DRAWINGS AND DESCRIPTION OF PROPOSED CHANGES

- any scaling from this drawing other than by the local planning authority solely for the purposes of the planning application to which it relates	
LOCATION	
job title	
TOTTENHAM HALE CENTRE	
ISLAND SITES

drawing title / location	
PROPOSED L02 FLOOR PLAN	
drawn by	checked
MG	AM
scale	status
1 : 250@A1, 1 : 500@A3	FOR APPROVAL
drawing number	revision
TH-IS_ZZ_001_A_16092_(P00)_P102	P04

3.4 BUILDING 1 UPPER FLOORS - SECOND FLOOR

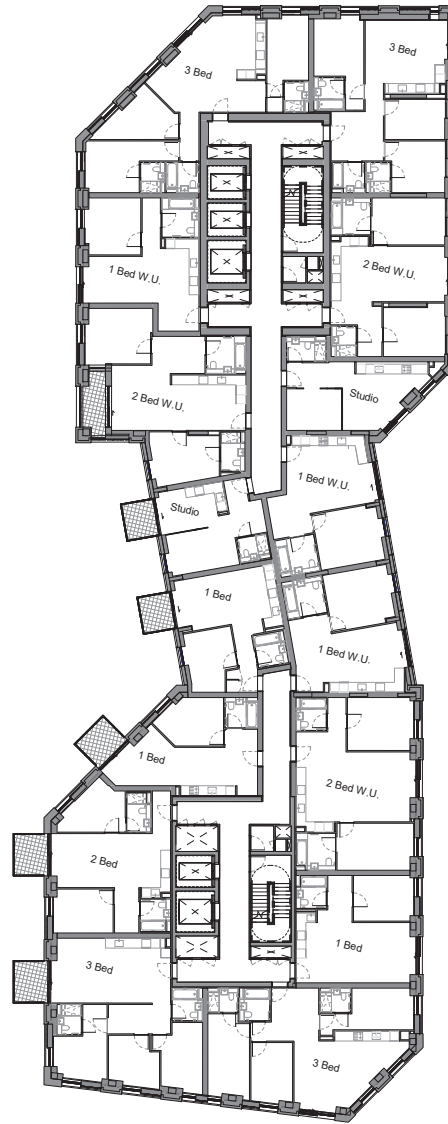
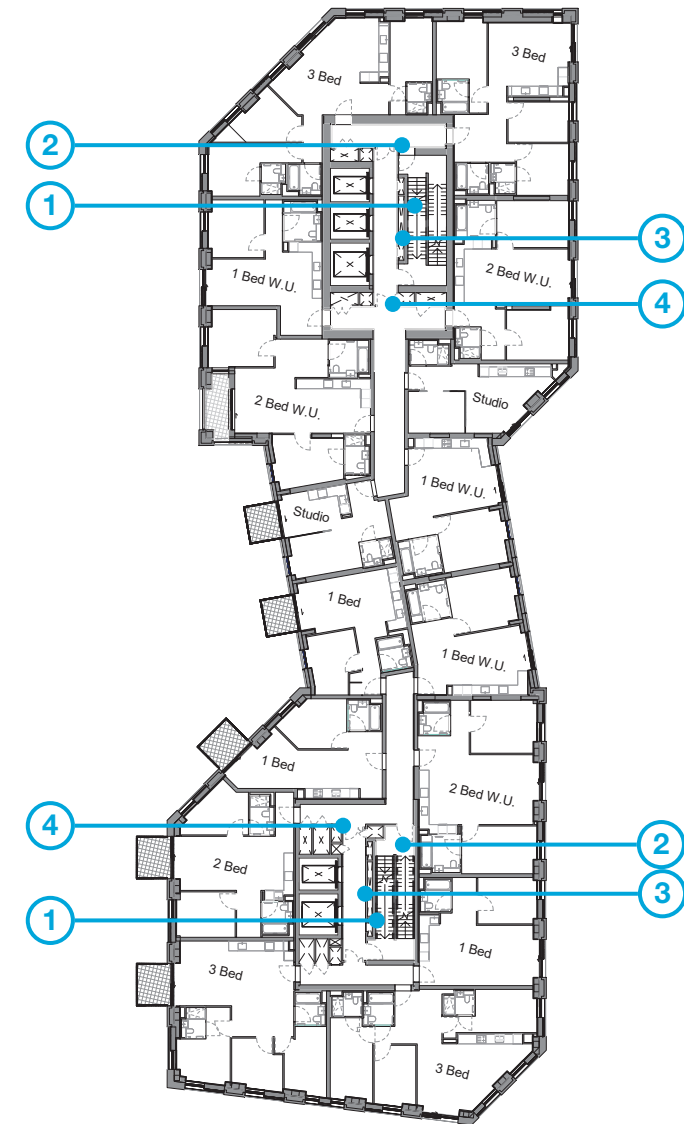
1. A second fire escape stair has been added between ground floor to upper levels.
2. Due to the addition of the second stair, the position of the access to the stairs has changed to resolve level changes across all floors.
3. Service risers have been relocated within the core following the addition of the second staircase.
4. Additional doors have been added within the communal corridors to comply with the latest fire strategy.
